# LASER INTERFEROMETER GRAVITATIONAL WAVE OBSERVATORY

Document Type	DCC Number T0900170-v1	April 16, 2009
<b>UK Top Driver Pre-Production Prototype Bench Test and Evaluation</b>		
J. Heefner, T. Etzel

**Figure 1: Top Driver Chassis Front**

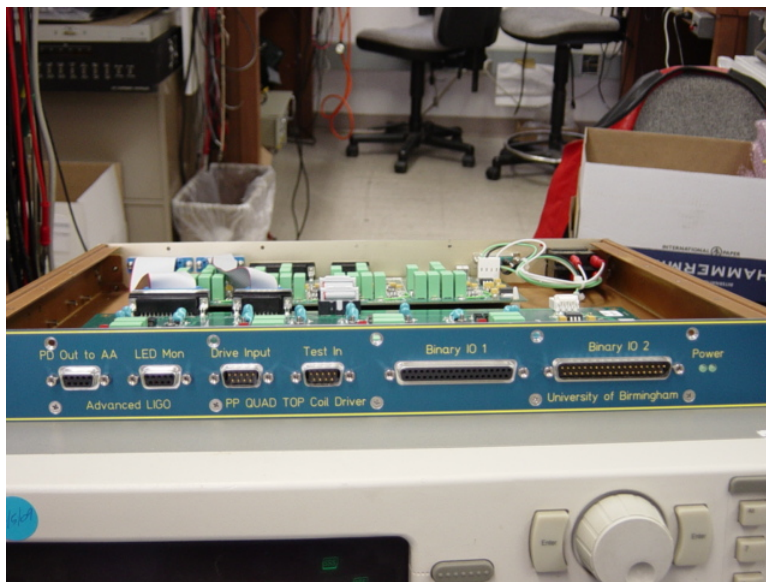
Referring to the figures above, it can be seen that the chassis is identified with a serial number and the drawing number associated with the driver schematic.

Power indicators are included on the front and rear panels. These labels and power indicators as well as the power switch are acceptable for production units.

**Figure 3: Top Driver Circuit Board**

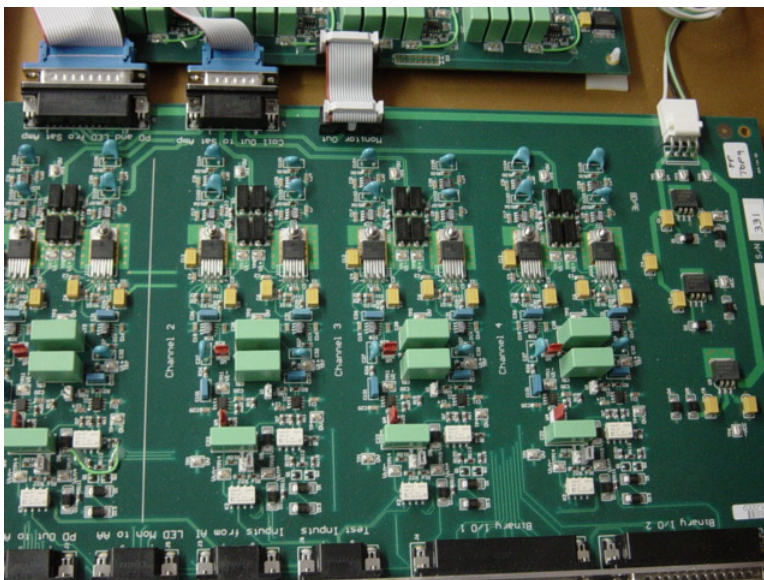
It cannot be clearly seen in the photograph, but the footprint used for the diodes is not correct and should probably be corrected prior to production as the spacing between the pads is much too large for the component used.

**Figure 4: Monitor Board**

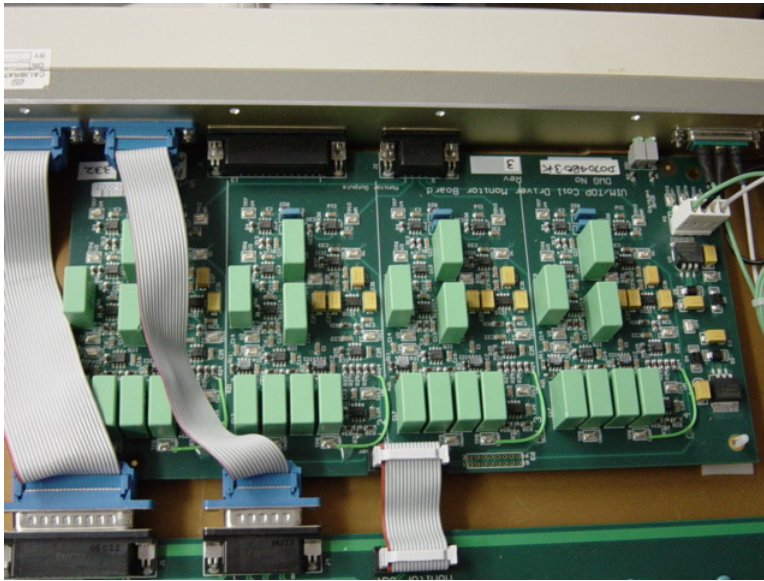
The Monitor board (figure above) was manufactured in a similar fashion and the only circuit board issues observed were jumpers used to correct a design mistake (see figure below). The circuit board artwork should be corrected to eliminate the need for these jumpers prior to production. Both boards (driver and monitor) are identified in the space provided with the drawing number, revision number and serial number for the board. The circuit board (pcb artwork) revision number is included on the silkscreen for each board.
